Important Technical Information..

U140E/F & U241E Linear Solenoid & Bracket Identification

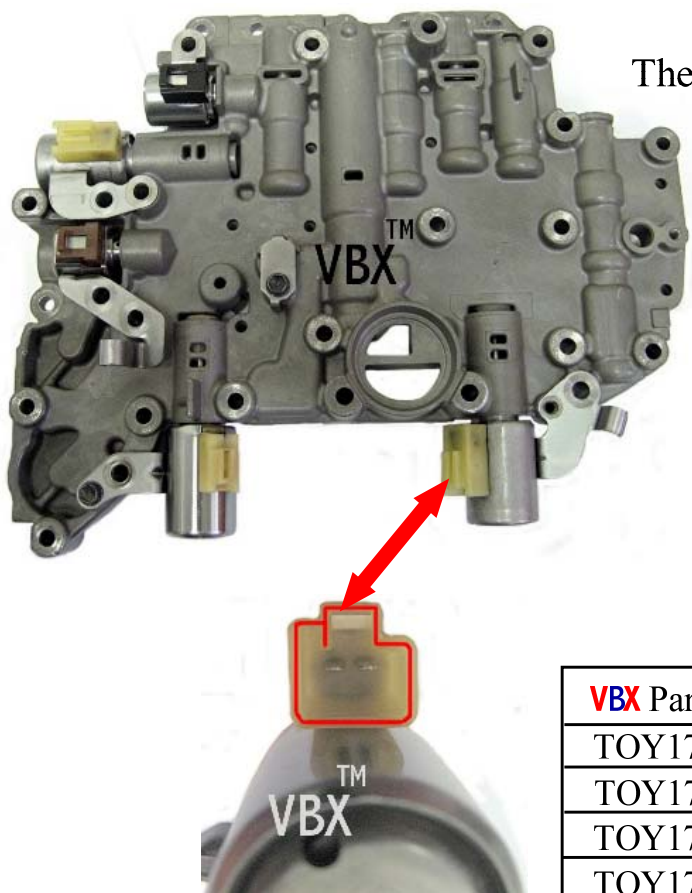
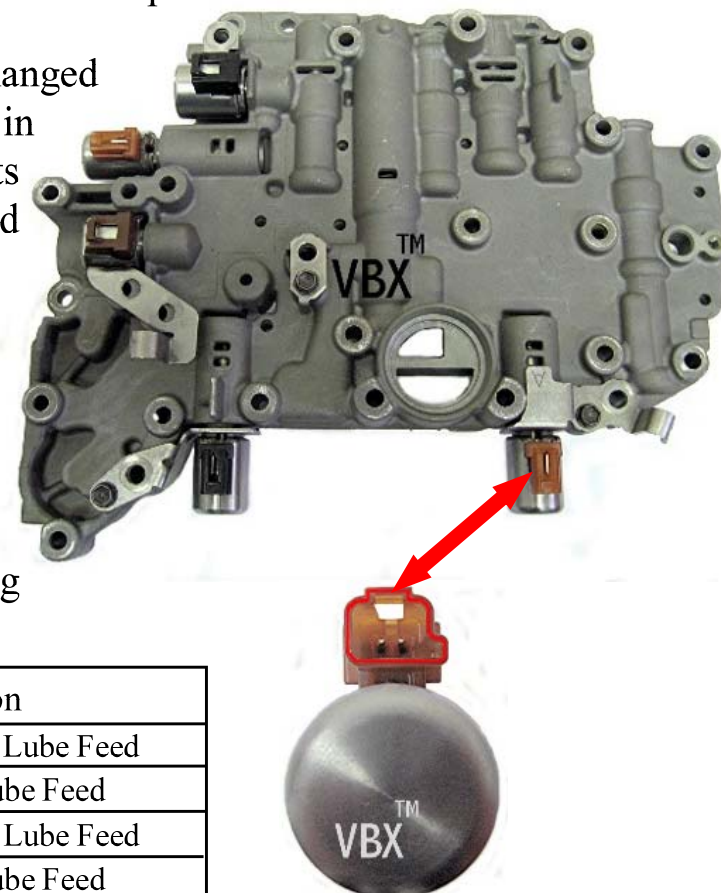
The linear solenoids and connectors changed in 2006. The solenoids are smaller in diameter and the retaining brackets are no longer permanently attached to the solenoids. In addition, the shape of the connector changed. See **RED ARROWS** in photos for differences in the connectors.
